SERVICE BULLETIN

APPLICABILITY: 2013MY BRZ

NUMBER: 02-151-14R

SUBJECT: Revised Valve Train Parts to Reduce a Warm Engine
 Tapping Sound from the Left Cylinder Head

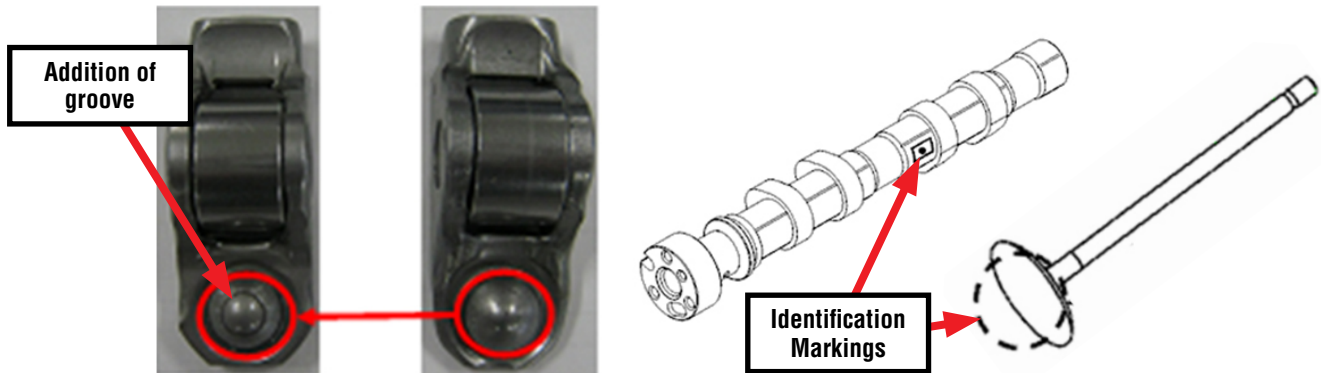
- Design change to the valve rockers
- Camshaft profile change
- 1.65mm longer intake and 2.47mm longer exhaust valve stem lengths

The illustrations below show additional information about the changes to the valve rockers, camshafts and valves to help readily distinguish them from the previous version parts.
